Subject: Duke Energy Corporation
Oconee Nuclear Station - Units 1, 2, and 3
Docket Nos. 50-269, 50-270, and 50-287

Revisions to Topical Report DPC-NE-3003 In Support of
Steam Generator Replacement
Response to NRC Staff Request for Additional
Information

Duke Power Response To Request For Additional Information

DPC-NE-3003 Revision 1 “Mass and Energy Release and Containment Response Methodology”

GOTHIC 7.0 - FATHOMS COMPARISON
ROTSG STEAM LINE BREAK
(0.6 ft² Break)

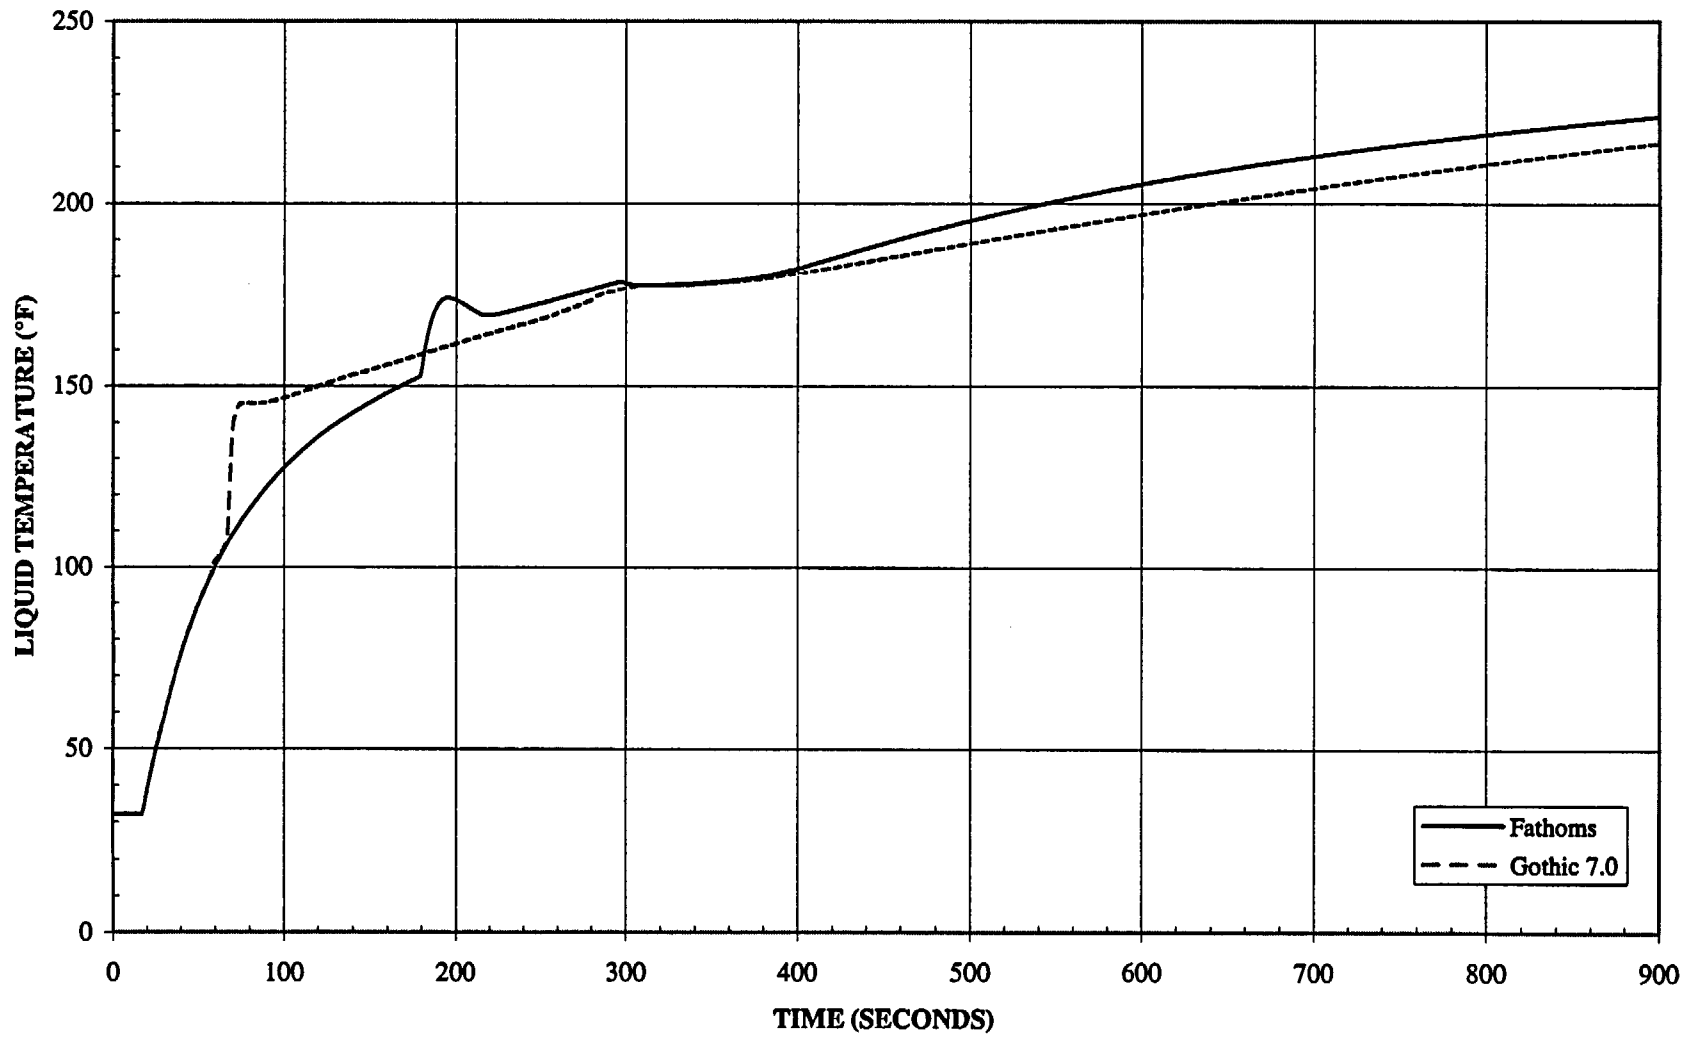
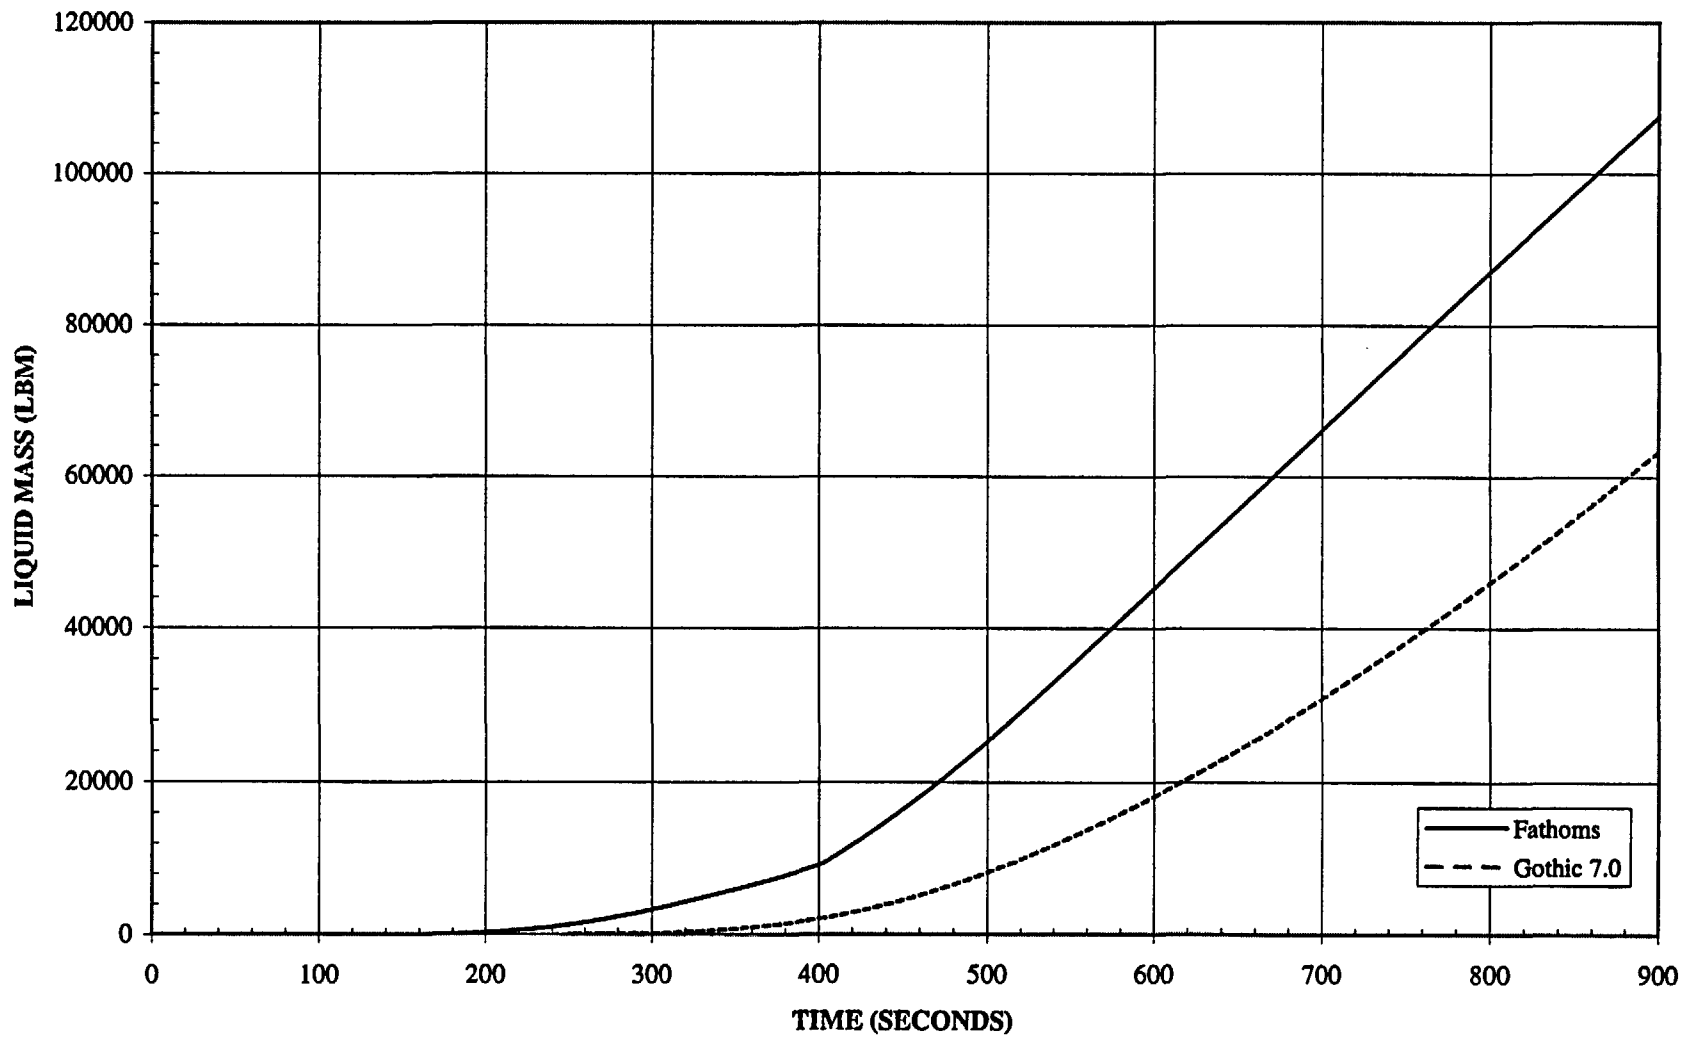
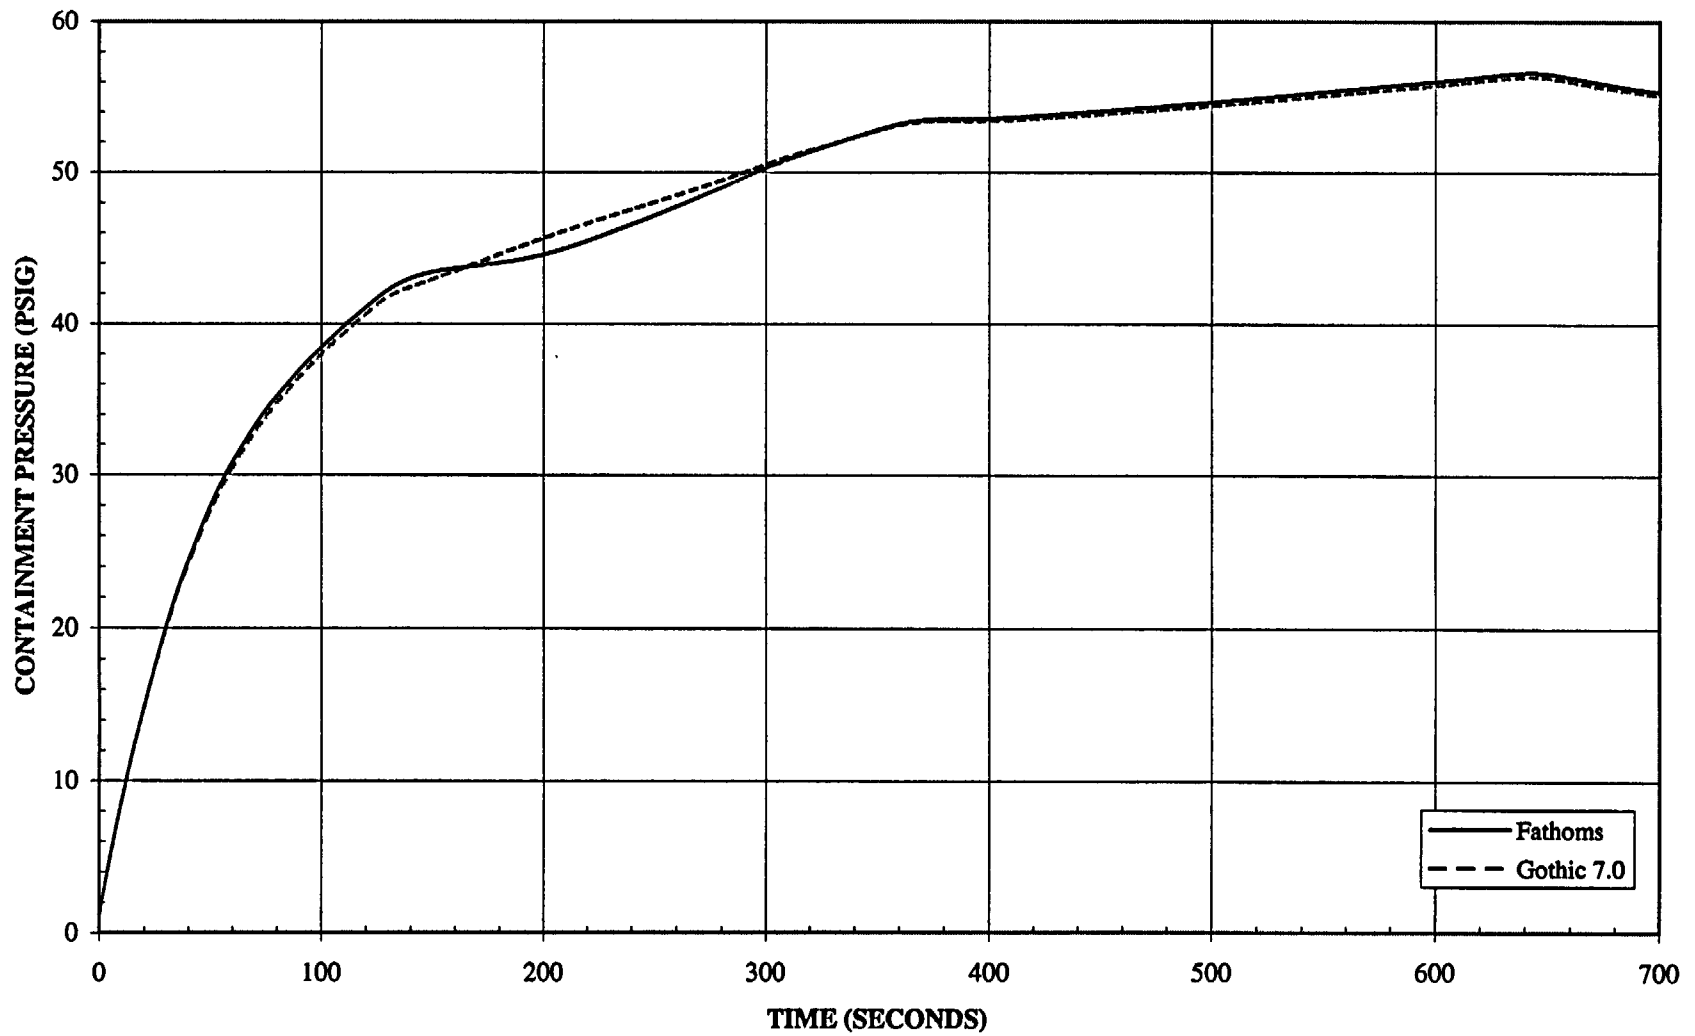
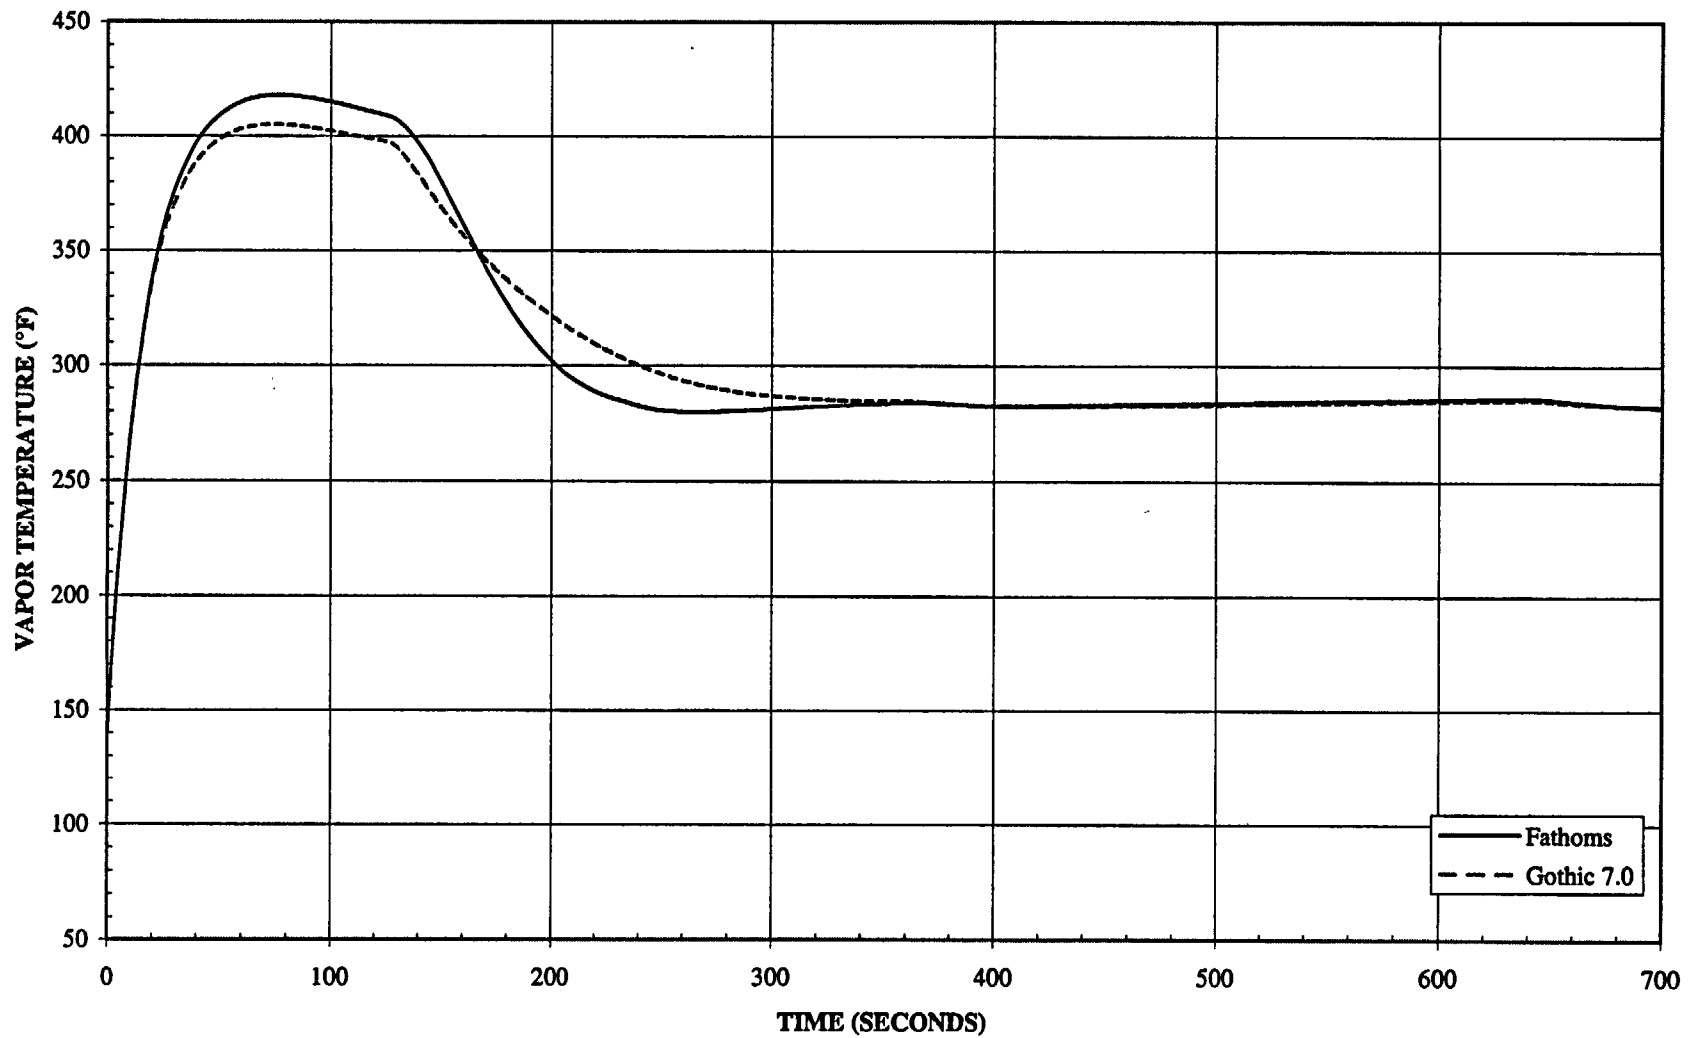
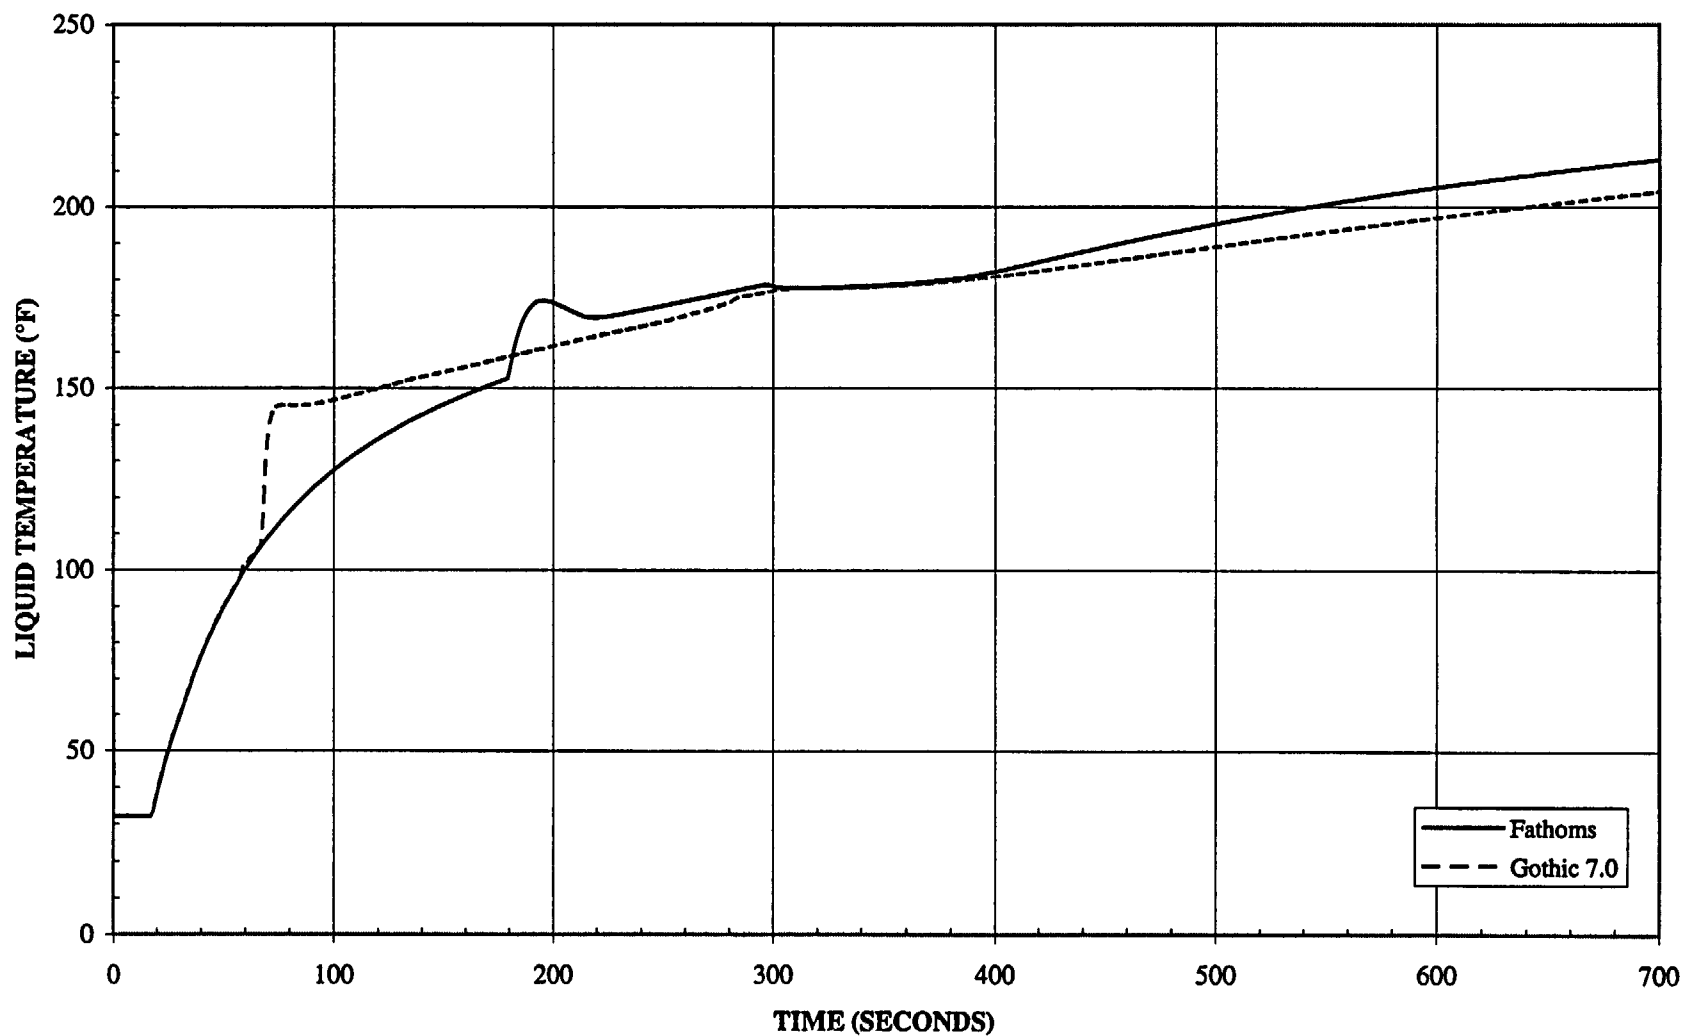
14. Show that GOTHIC and FATHOMS calculations result in the same pressures, temperatures, sump temperatures, etc. for the design basis LOCA and main steam line break events. If they do not, explain differences in terms of the differences in models between the two codes. (See Question 1.)

Response: Refer to the response to Question #3 for LOCA. The results of the 6 code comparison analyses for the main steam line break are given in Table 14-1 and the figures that follow. The containment response following a main steam line break event for the ROTSG was performed to compare the results from FATHOMS 2.4 and GOTHIC 7.0. In general, the pressure and vapor temperature responses are very similar. GOTHIC 7.0 predictions for peak pressures are slightly lower on the smaller break sizes (~0.3 psi) and slightly higher for larger break sizes (~0.95 psi). The peak vapor temperature responses predicted by GOTHIC 7.0 overall are slightly lower (~12°F). For larger break sizes, the higher pressure predicted by GOTHIC 7.0 may be attributed to additional steam generation from the improved interface heat and mass transfer models and from the drops that are generated due to dripping. The slightly lower pressure for smaller break sizes may be attributed to additional droplets in the atmosphere. The slightly lower vapor temperature and liquid temperature in GOTHIC 7.0 for all break sizes may be attributed to additional droplets in the atmosphere also. This effectively increases the heat capacity of the atmosphere and reduces the temperature rise for a given energy addition. As discussed in the responses to Questions #1 and #3, more liquid is predicted to remain in droplet form in GOTHIC 7.0 which results in less liquid mass in the sump. In addition, the lower sump temperature predicted by GOTHIC 7.0 may be attributed to the addition of the second energy equation for the drops and the improved heat and mass transfer models in GOTHIC 7.0.
